Town of Arlington, MA Redevelopment Board

Agenda & Meeting Notice June 2, 2025

2. Public Hearing: Docket #3849, 259 Broadway

To: Arlington Redevelopment Board
From: Claire V. Ricker, AICP Secretary Ex-Officio
Subject: Site Plan Review, 259 Broadway, Docket #3849
Date: May 29, 2025; [revised May 30, 2025](#)

2 PROPOSED SITE PLAN
SCALE: 1/8" = 1'-0"

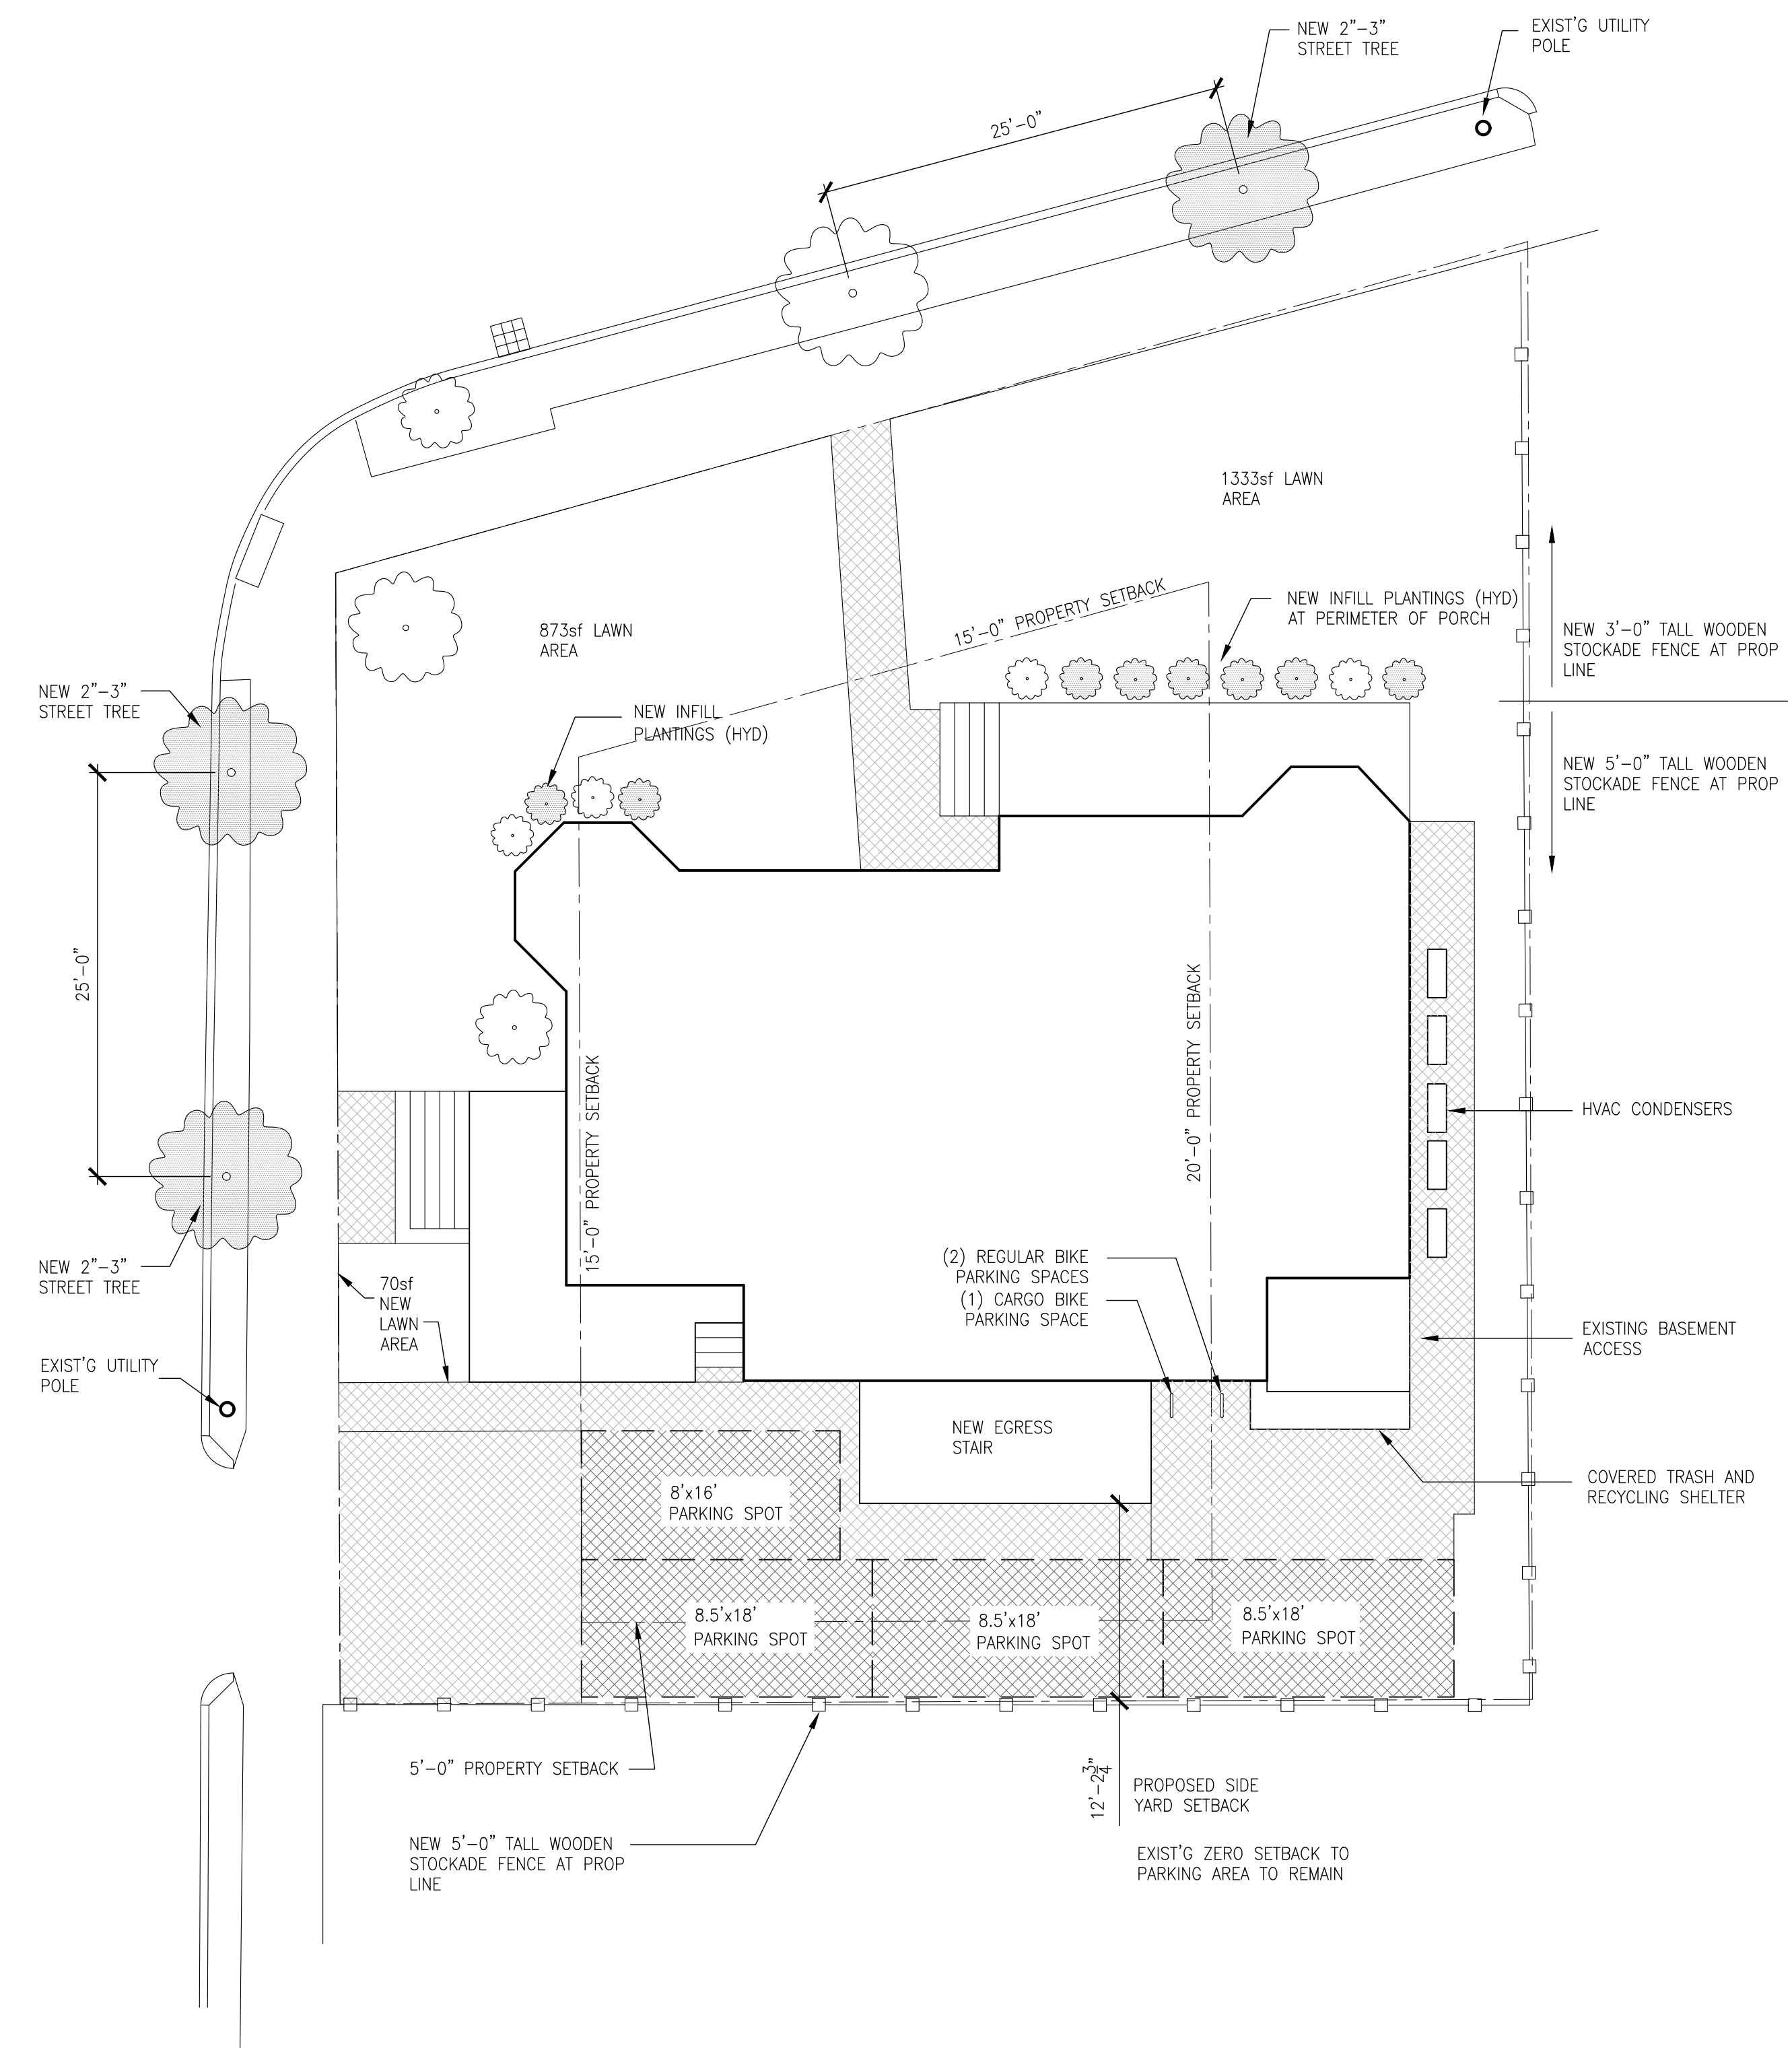
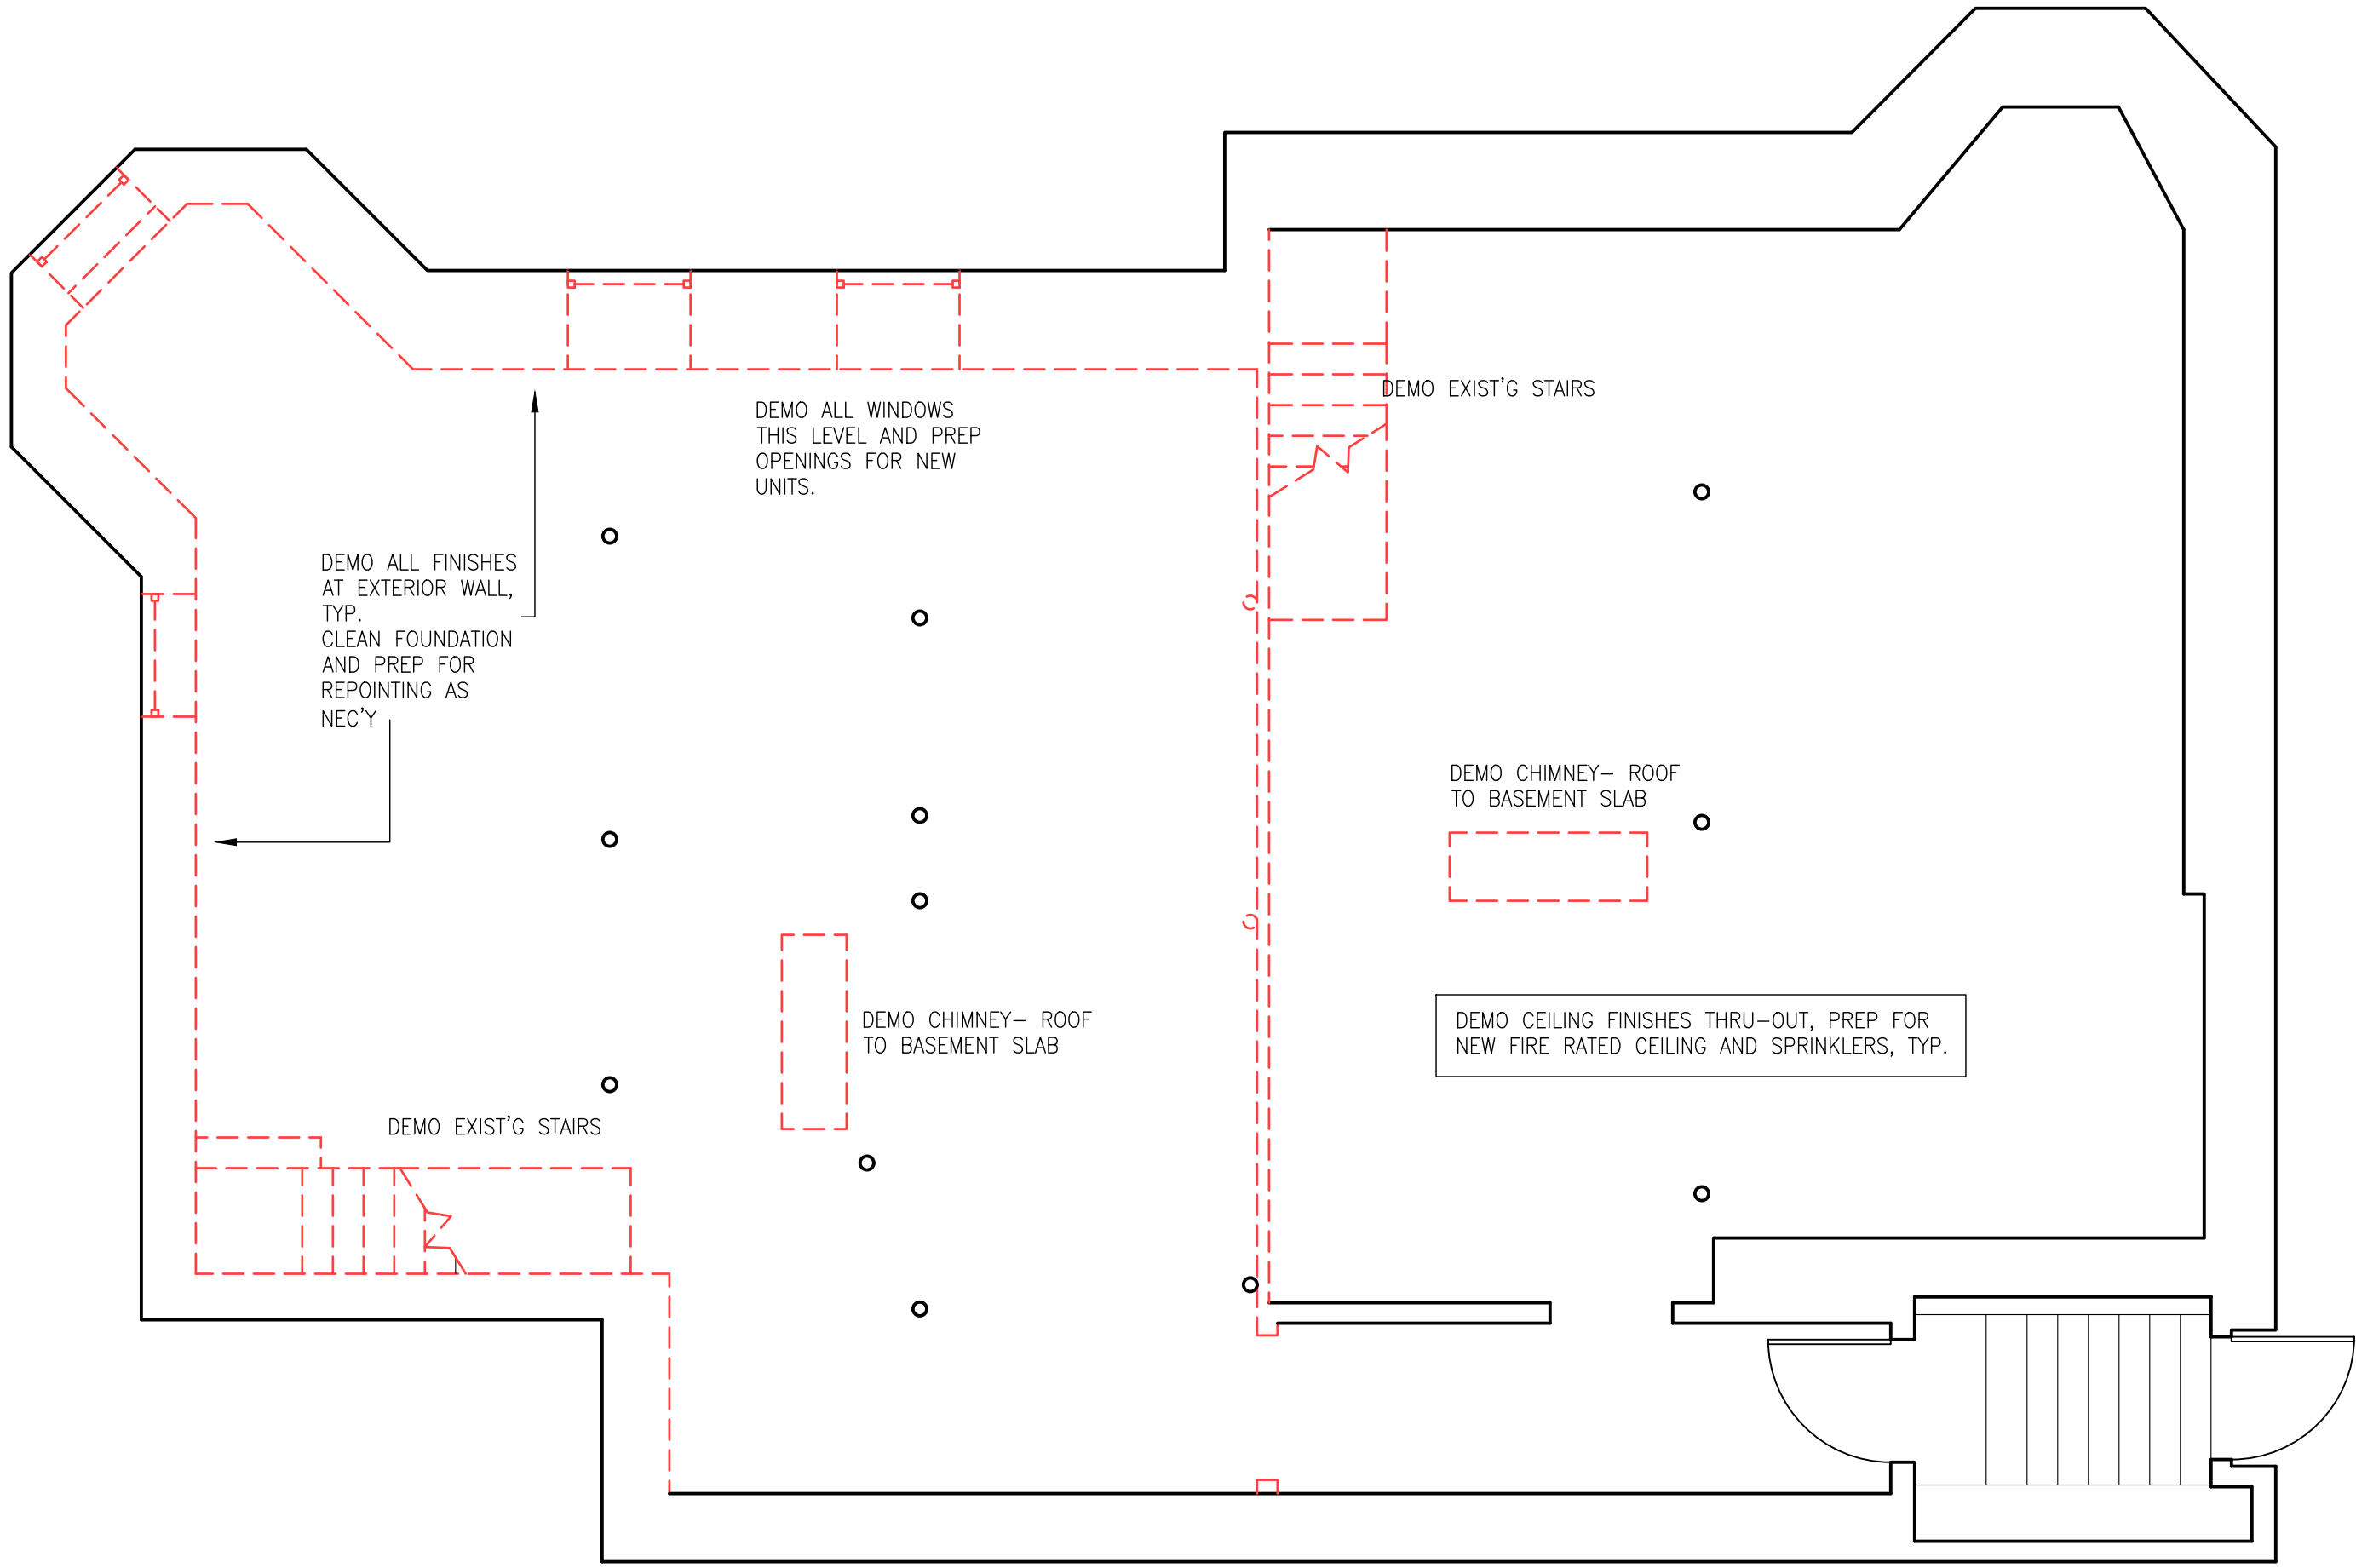
Under the proposal, the number of parking spaces provided will not change. The garage will be demolished with that area continuing to be used for parking. Two EV chargers will be installed, although the locations are not shown on the site plan.

Existing walkways on the site are adequate. Bicycle racks able to accommodate at least one cargo bike will be installed at the rear of the driveway. Long-term bicycle parking will be located down a short flight of stairs in the basement. The applicant should clarify whether a ramp is proposed for the basement stairs and show the location of the proposed racks and 8 long-term spaces on the site plan.
